8280 Wisconsin Avenue: Sketch Plan No. 320180150

- Request for a non-residential development with a maximum density of 185,000 square feet. The maximum density includes up to 93,388 square feet of density from the Bethesda Overlay Zone (BOZ), with a Park Impact Payment;
- Current use: gas station;
- Located in the southwest quadrant of the intersection of Montgomery Avenue and Battery Lane in Downtown Bethesda;
- 0.75 gross acres Zoned CR-3.0, C-3.0, R-2.75, H-145 and the Bethesda Overlay Zone (BOZ) in the 2017 Bethesda Downtown Sector Plan area;
- Applicant: Donohoe Development Company and Stonebridge Carras
- Accepted on 4.19.2018

RE: Sketch Plan No. 320180150
8280 Wisconsin Avenue

Figure 6 – Perspective Views of Wisconsin Avenue corner, looking south

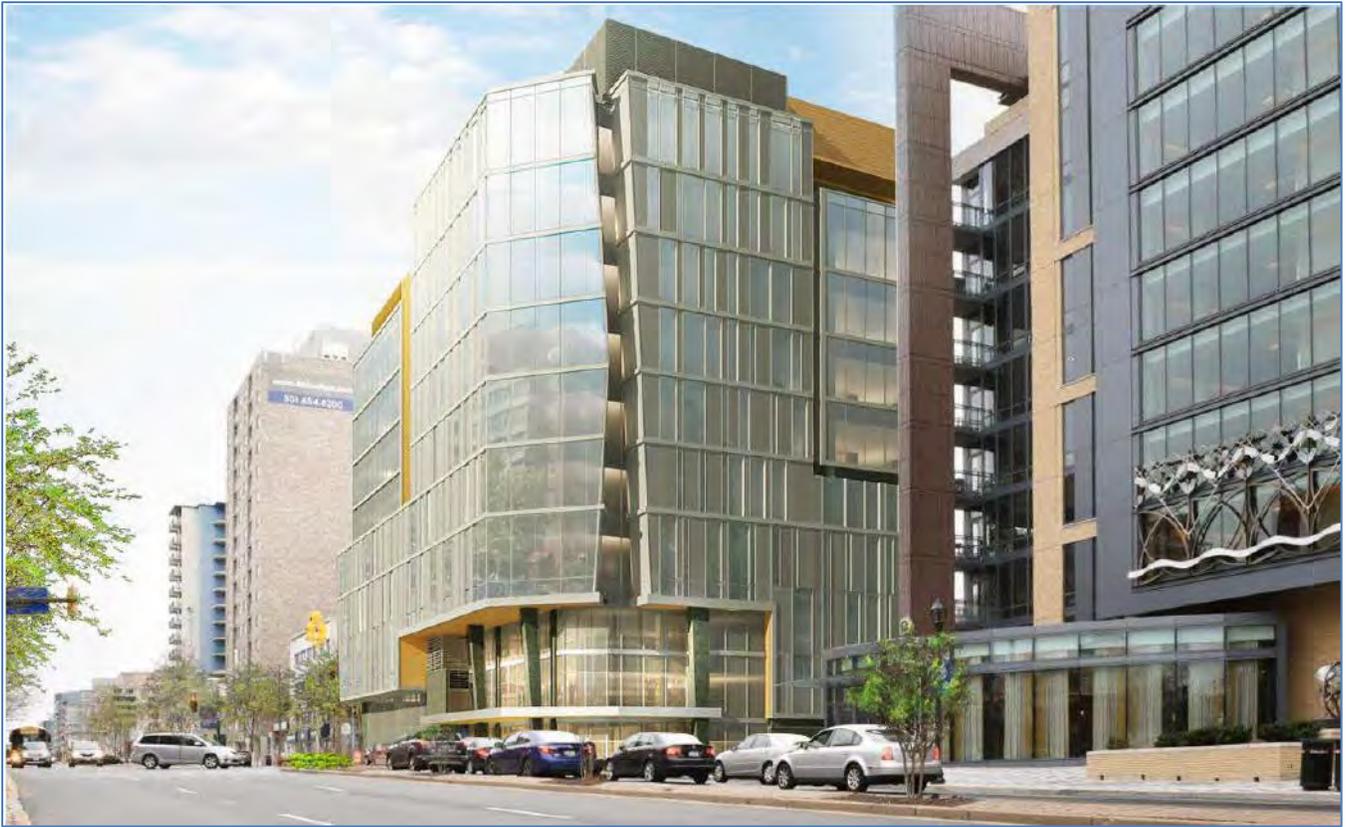
Staff notes that the submitted Sketch Plan design projects a substantial portion of the building into the public right of way for Wisconsin Avenue. This is not consistent with a strict interpretation of the Design Guidelines, and will need to be reviewed further by Staff, the DAP, and the reviewing agencies at the time of Site Plan.

Figure 7 – Diagrammatic Building Section Looking South

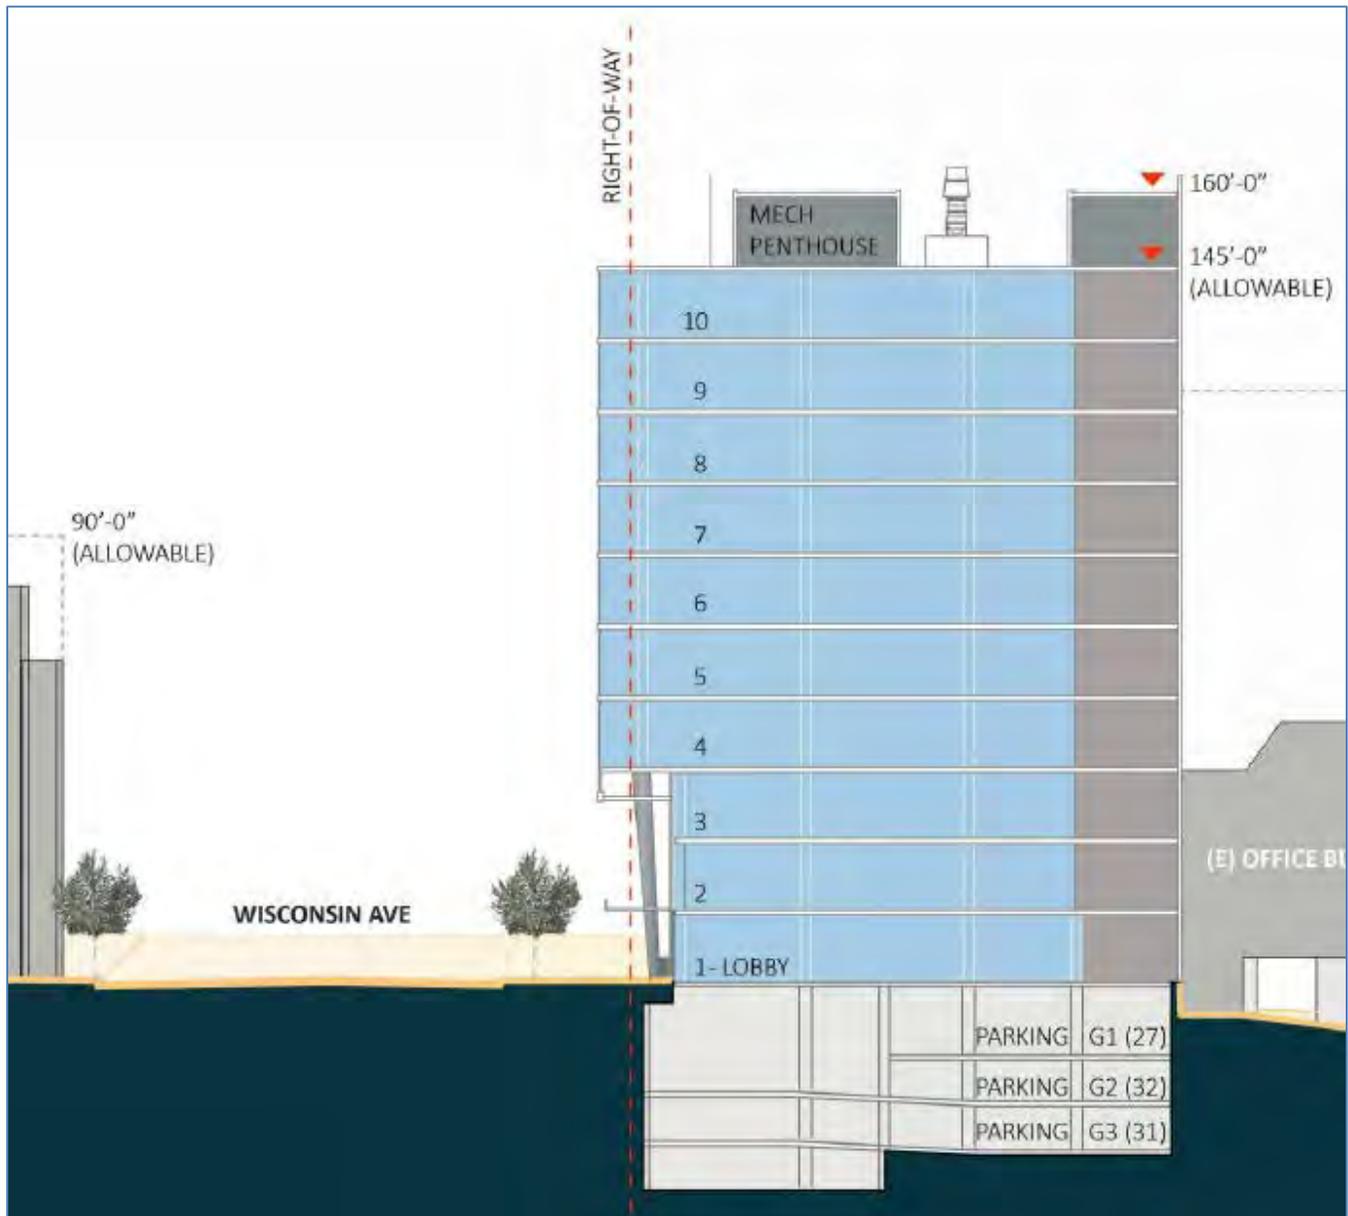
The Project's proposed massing does not fully conform to the building form goals and recommendations for the Wisconsin Avenue Corridor District in the Sector Plan, page 104. The Project's mass and bulk is imposing, not having a human-scaled presence on the street by proposing a building projection into/over the pedestrian realm (sidewalk) above the building base of more than 8 feet in depth along the Wisconsin Avenue facade. At the time of Site Plan the Project must address the Sector Plan, Section 3.1.1.B.2.a Building Form.

Figure 8 - Vehicular & Pedestrian Circulation

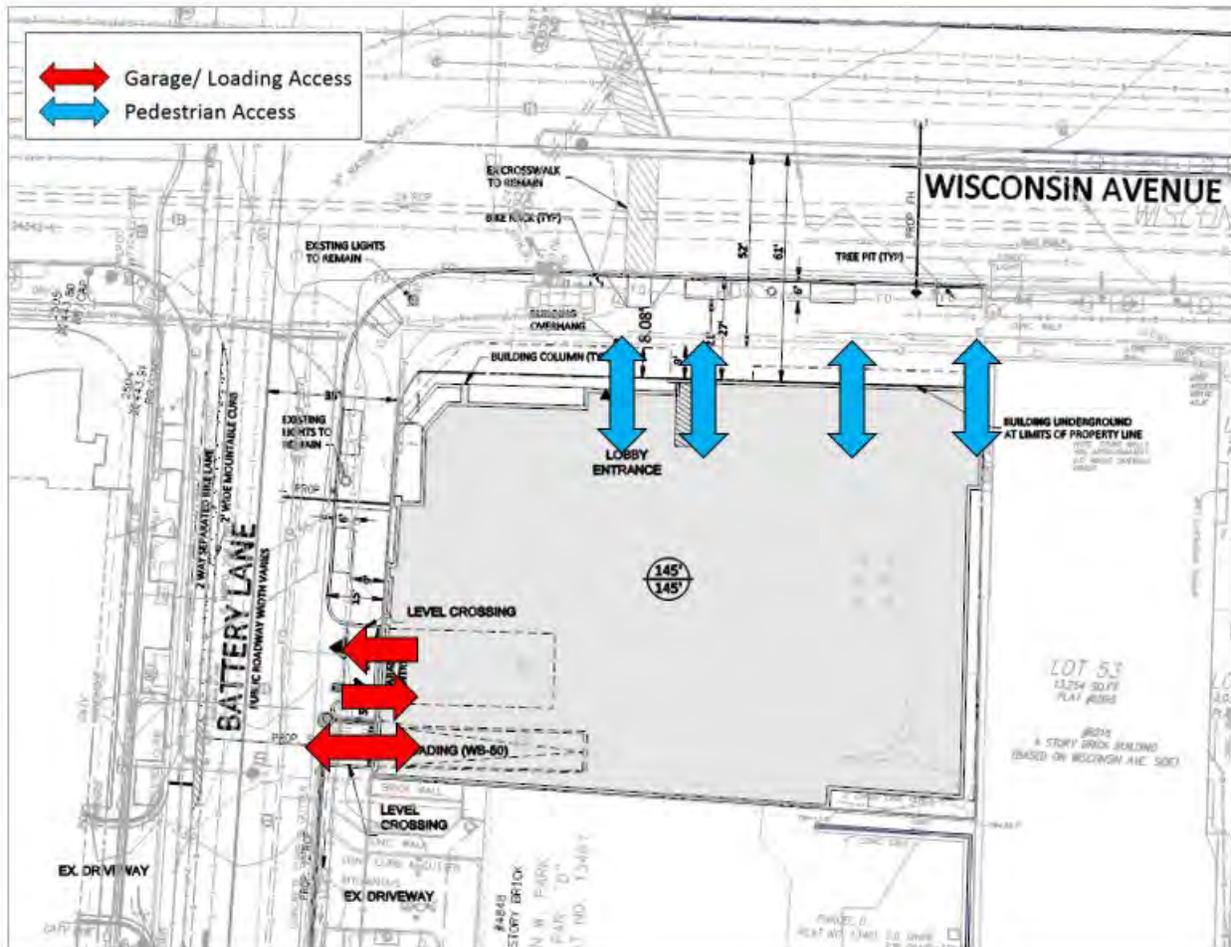
Vehicular access to the Property is proposed directly from Battery Lane through a consolidated garage access point and loading bay (two separate, but adjacent entrances) at the northwest corner of the site (Figure 8). This configuration eliminates vehicular access from Wisconsin Avenue (MD 355) and minimizes interruptions to the pedestrian realm.
